Huawei Technologies Co.,Ltd.

Class 2 Permissive Change Letter

Pursuant to section 2.1043, We **Huawei Technologies Co., Ltd.** Hereby submit a request for class II permissive change to our product, FCC ID: QISMU709S-6, Grant date: 10/09/2018

Differences between the old MU709s-6 (LGA) and the new MU709s-6 (PCIE)

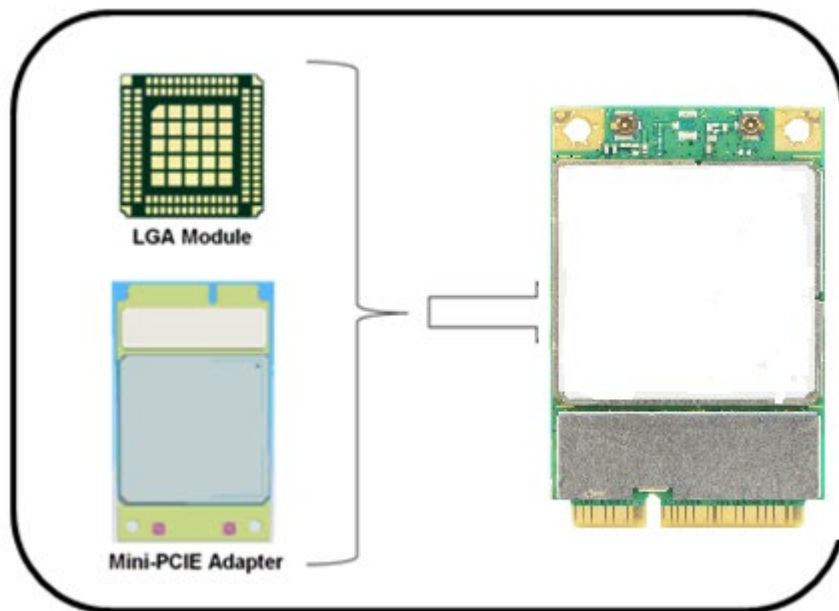
- 1) no hardware changes in RF part
- 2) modification in the host interface as described below

There is the same hardware and software between the MU709s-6 (LGA) and the MU709s-6 (PCIE). The only interface changes from LGA to PCIE.

The new MU709s-6	The old MU709s-6
Working bands	The same	The same
Power Voltage	3.0 V to 3.6V (3.3 V is recommended.)	3.3 V to 4.2 V (3.8 V is recommended.)
Interface	PCIe interfaces	145-pin LGA interface
Hardware	The same	The same
Software	The same	The same
